4. CASE 21.097, 230 BROWN STREET, House, post 1895 (COLLEGE HILL)

Project: Three Family Residence
Address: 230 Brown Street, Providence, RI 02906
Date: 12 September 2021
Re: Application Information

PROPOSED WINDOW SASH REPLACEMENT
THREE-FAMILY BUILDING
230 BROWN STREET
PROVIDENCE, RHODE ISLAND 02906

HDC SUBMISSION

SHEET **A1.1**

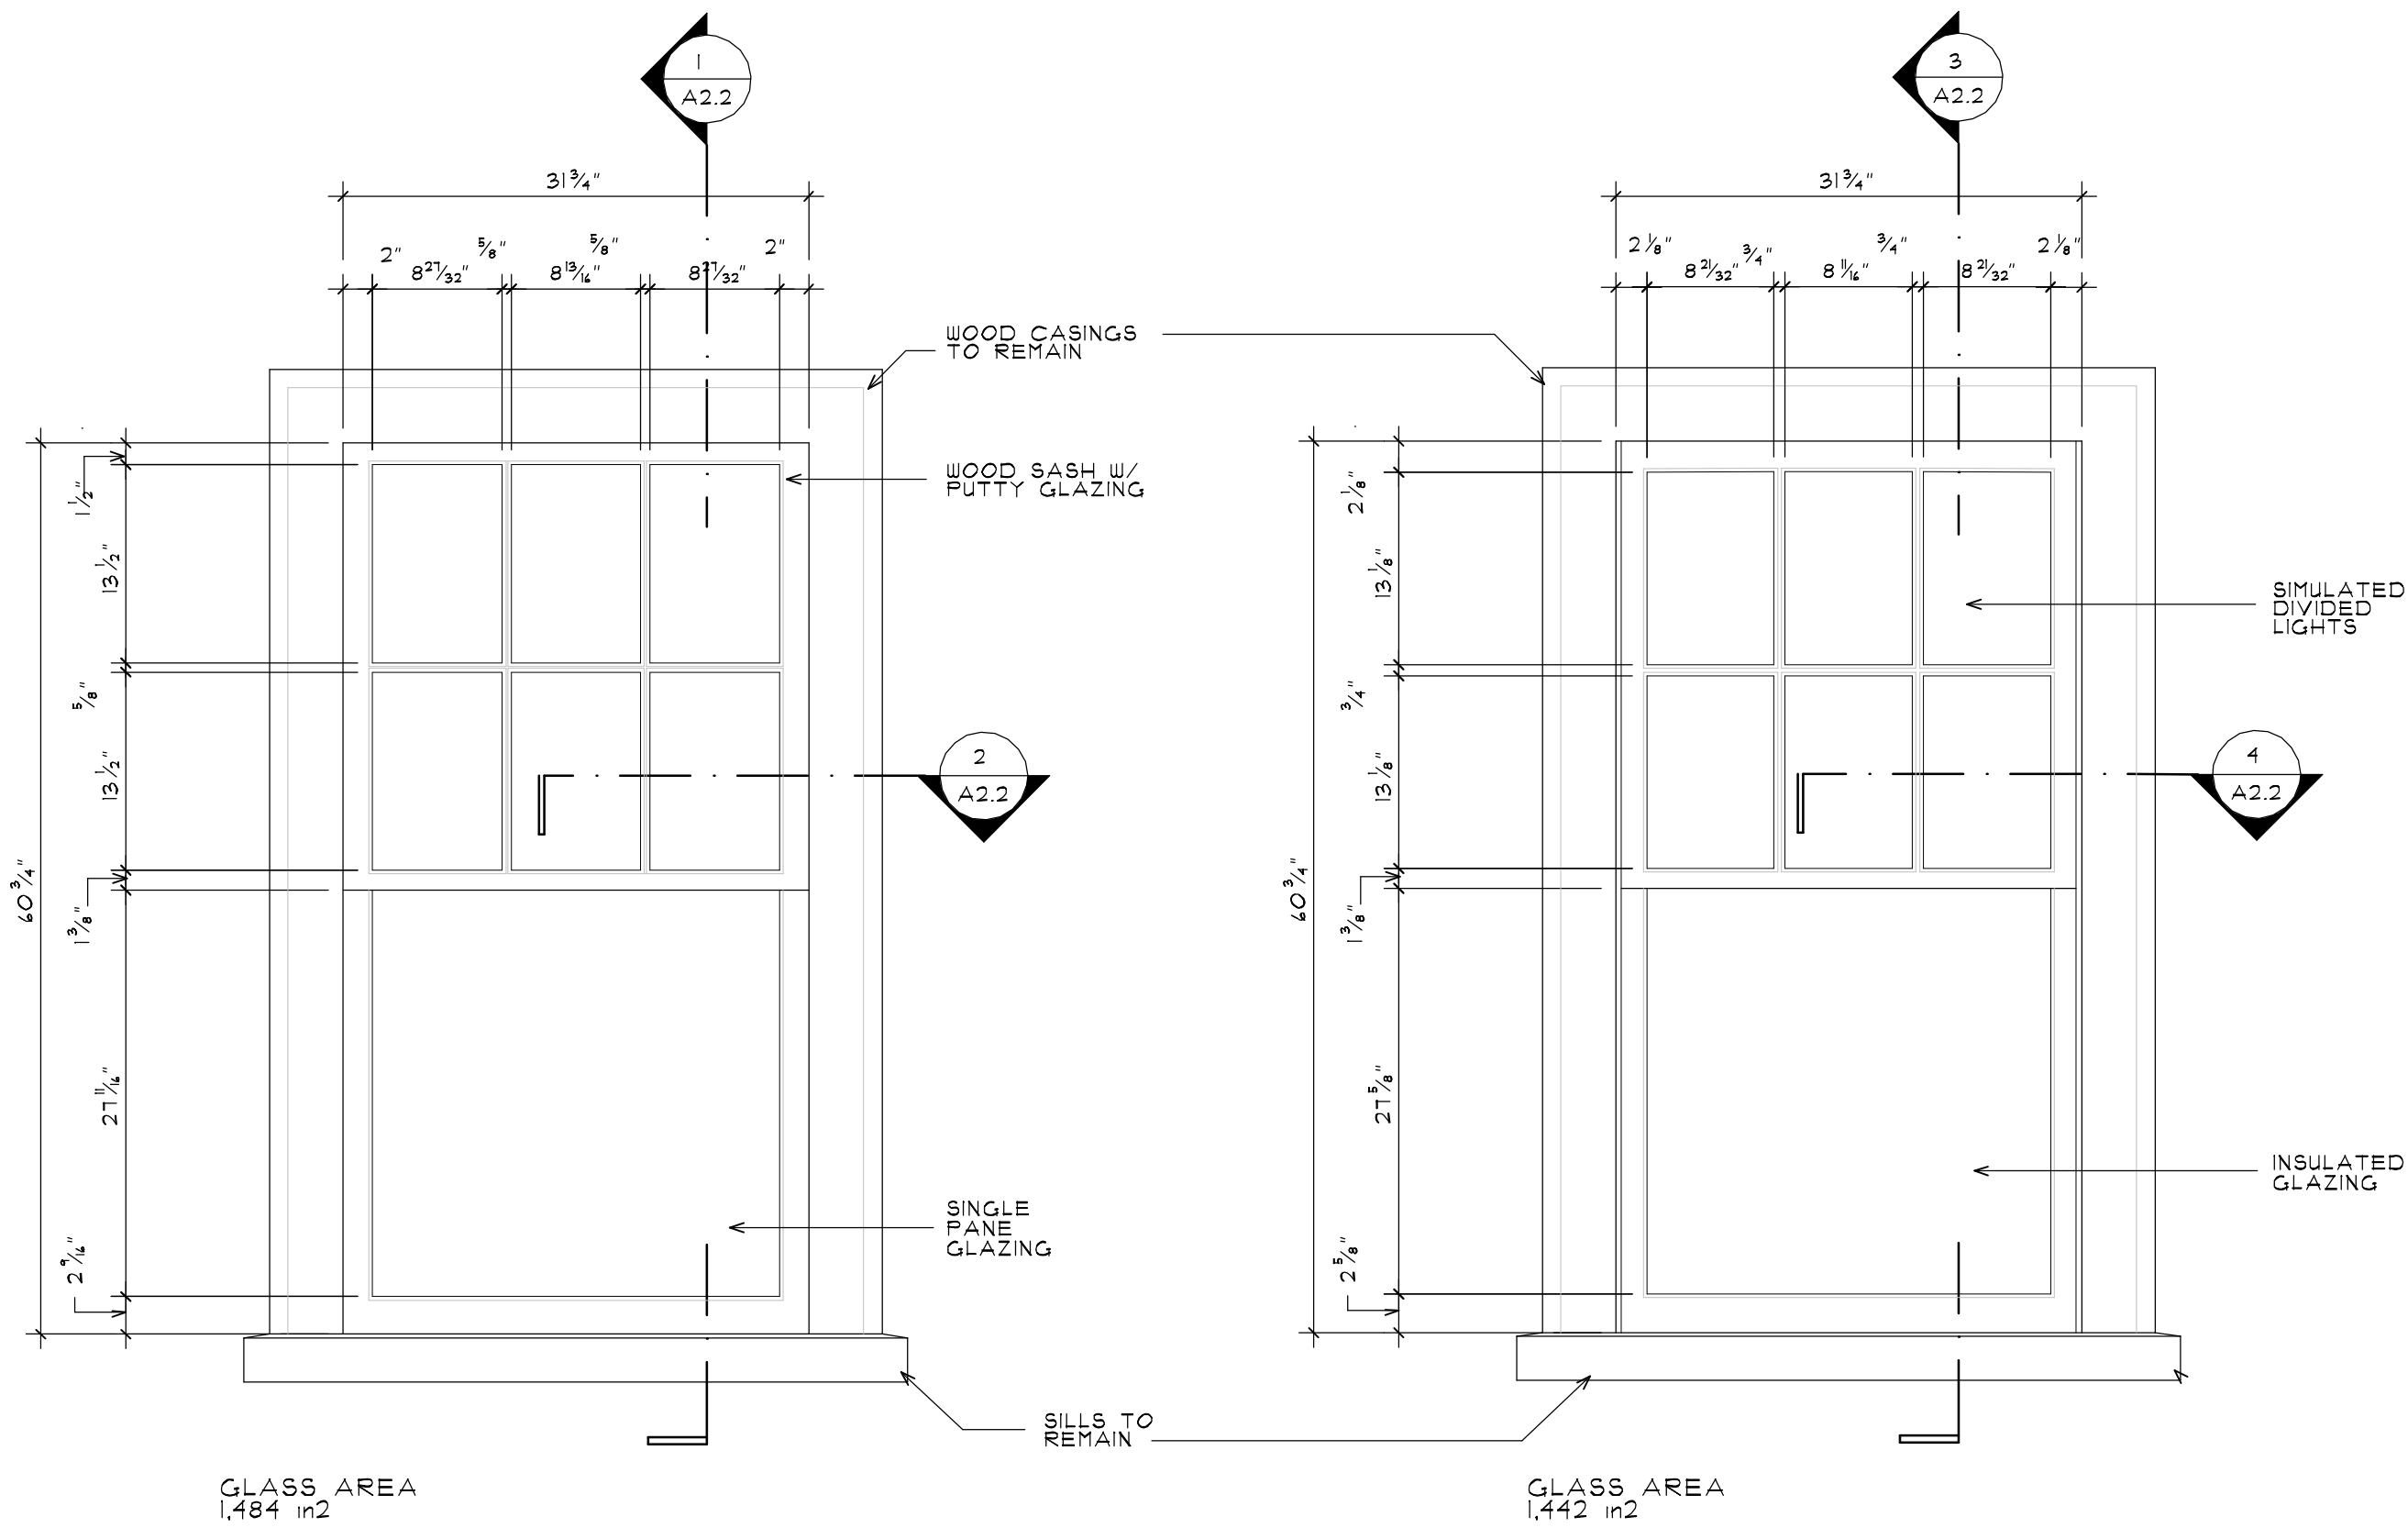
- **Sash Replacement:** The double hung units are to be replaced on three floors, in current configuration. On the attached window schedule, they are units A, B, C, D, I, K & L. There are four fixed sashes in the west stair, unit H, which shall be placed as a 6-light unit. Window "F" is single hung window with small light upper sash. The lower sash shall be replaced with insulated unit, the upper fixed sash shall remain in place.
The new double hung sashes shall be Trimline Ultra Fit (Classic Clad) sash replacement kit. These are wood units, insulated glazing with aluminum clad exterior and vinyl jamb liners. Muntins to be simulated divided light. Exterior color to be earth tone (chocolate brown). New window screens to be half-window. The existing sashes and aluminum storm windows shall be removed.

Staff recommends a motion be made stating that: The application is considered complete. 230 Brown Street is a structure of historical and architectural significance that contribute to the significance of the College Hill local historic district, having been recognized as a contributing structure to the College Hill National Historic Landmarks District. The Commission grants Final Approval of the proposal as submitted having determined that the proposed alterations are appropriate as the proposed alterations are architecturally and historically compatible with the property and district having an appropriate size, scale and form that while diminishing the historic quality of the property will not have an adverse effect on the property or district and allows the property to come into compliance with RIGL § 42-128.1-8, citing and agreeing to the recommendations in the staff report, with staff to review any additional required details.
